SLG46108-EV Errata Note

This document contains the known errata for SLG46108-EV and the recommended workarounds.

Figure 1. Testing Design and Settings

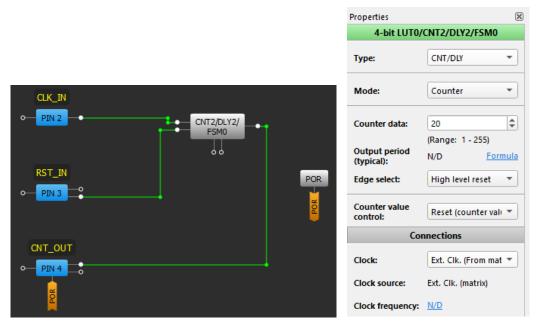
Counter Reset is asserted at the same time as a rising clock edge

If the Counter Reset is asserted at the same time as a rising clock edge, it is possible that the Counter Data will be reset incorrectly and the counter output may appear faster than expected, it doesn't depend on the edge select option. This phenomenon appears more often as the clock frequency increases.

Synchronize the RESET input of the Counter with its CLK using 2 DFF cells as shown in Figure 3.

Figure 4. OSC Frequency vs. V_{DD}

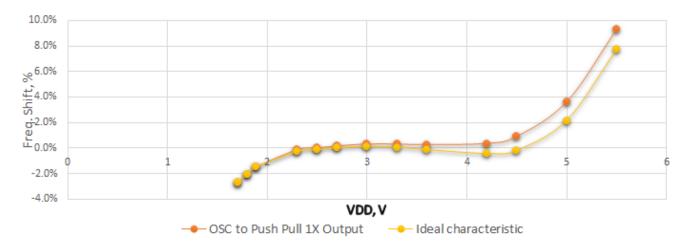
While applying some high-frequency noise to the VDD, OSC inaccuracy may increase. The same behavior is also present in cases where high-frequency switches are outputted from the chip using the Push-Pull type driver. See, the test results in Table 1.

Currently, there are no viable workarounds for this issue. However, the issue can be minimized by doing the following:

- Only use frequencies lower than 2 MHz when switching the output.
- Do not use parallel PIN connections to output high-speed switching signals.

Figure 6. Testing Design

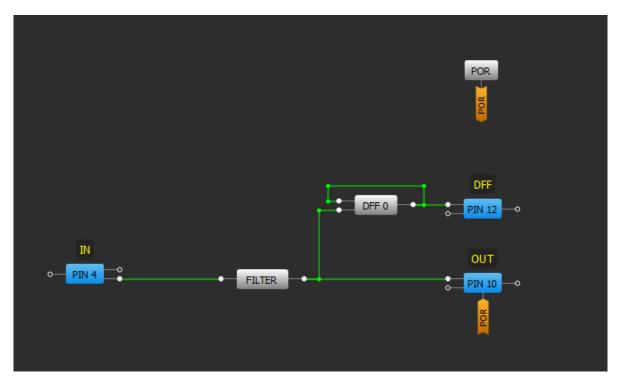
If high-frequency clock input comes in, the FILTER cell may not filter out it. There are several factors like input frequency, duty cycle, and LOW duration in such signal that may lead to its passing through the FILTER block.

Currently, there is no workaround for this issue. Filter block is good at filtering short spontaneous glitches. It is intended to be used in a series connection before the delay cell to avoid its latching.

Figure 11: Problem Trigger Pattern

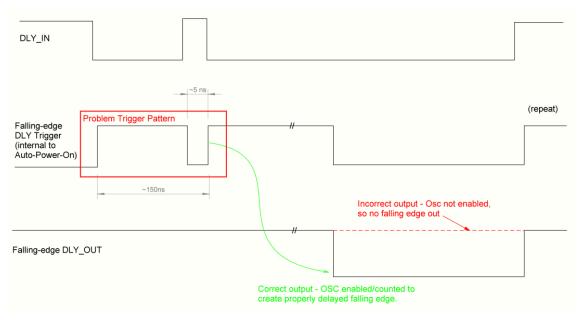
For this chip, the Auto Power On circuitry of the 25 kHz/2 MHz generators contains a circuit errata, which can potentially fail to power on the OSC for a specific pattern and timing of the OR of all related DLY trigger signals. The pattern is shown in Figure 11 (boxed in red) and consists of a relatively longer pulse (~145 ns) followed by a shorter (~5 ns) glitch of opposite polarity.

- Use signal conditioning circuits to prevent glitches on DLY inputs < 200 ns. Examples:
 - ACMP with Hysteresis
 - External RC in front of Digital Input with Schmitt Trigger
 - Filter cell.
- Set OSC power mode to Force Power On mode instead of Auto Power On.
- Use a different oscillator, such as 25 MHz Ring OSC, which does not have Auto Power On issue.

Figure 12: Test Circuit

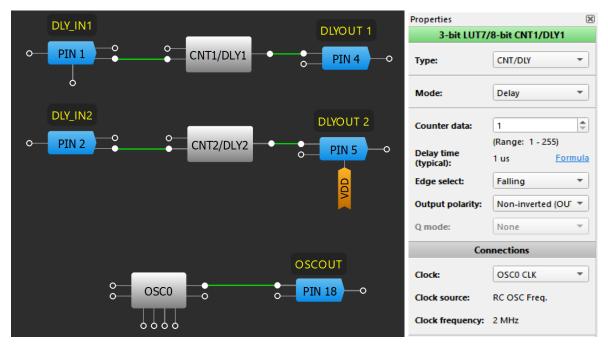
The error is difficult to capture as the timing must be exact within ns, and short (ns) pulses are difficult to generate glitches precise enough to induce the problem. GPIO naturally filters out ns pulses, so for purposes of errata capture, two simultaneous falling-edge DLY circuits (as shown in Figure 12) were used. By lining up two delays precisely at a particular timing relationship, we can use the internal Auto Power On (OR logic) to generate the glitch pattern necessary to cause the error.

Figure 13: Errata Capture (Zoom Out)

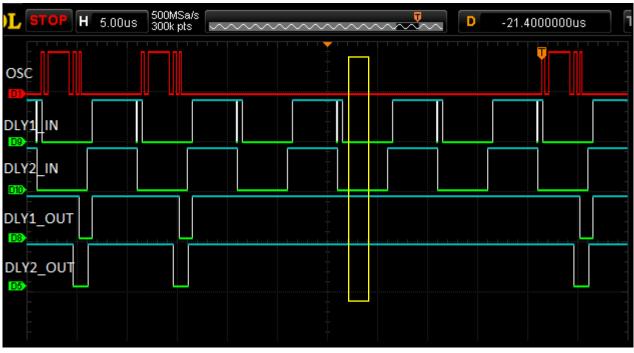
Figure 13 shows a series of DLY output events are missing, where the OSC is correspondingly not triggering when it was supposed to. Figure 14 is a zoom-in of the boxed region from Figure 13. The total glitch/chatter time was measured in this case at 152 ns. By using the composite OR of the two delay channels, we can asynchronously strobe with tiny frequency variations, and so tune the timing to induce this errata. Note that the error is not persistent – the system is recovered when all DLYs are returned to inactive state, such as when input of falling edge DLY goes high, thus canceling delay, or after DLY out finishes.
